### Moved thermocouple hole in burner area

#### DESCRIPTION

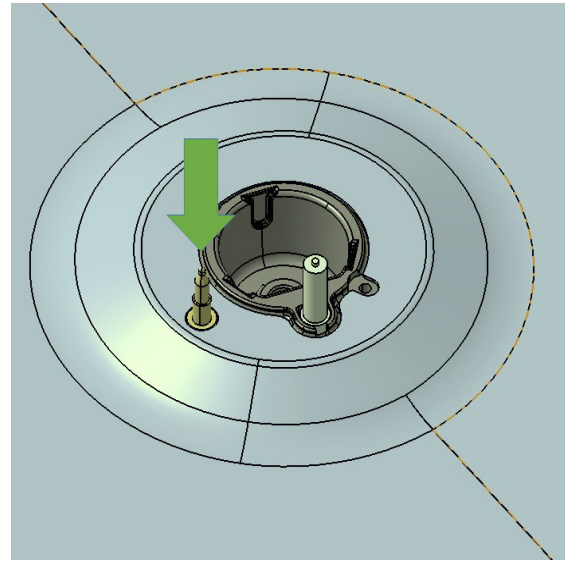
In gas hobs equipped with side control knobs, position of thermocouple hole has been moved within burner area. Spare part codes for work tops remain the same.

Position of thermocouple hole before modification

Position of thermocouple hole after modification

Modification of thermocouple hole has no impact on interchangeability of work tops. It is only required to fit thermocouple sensor in new position of hole.
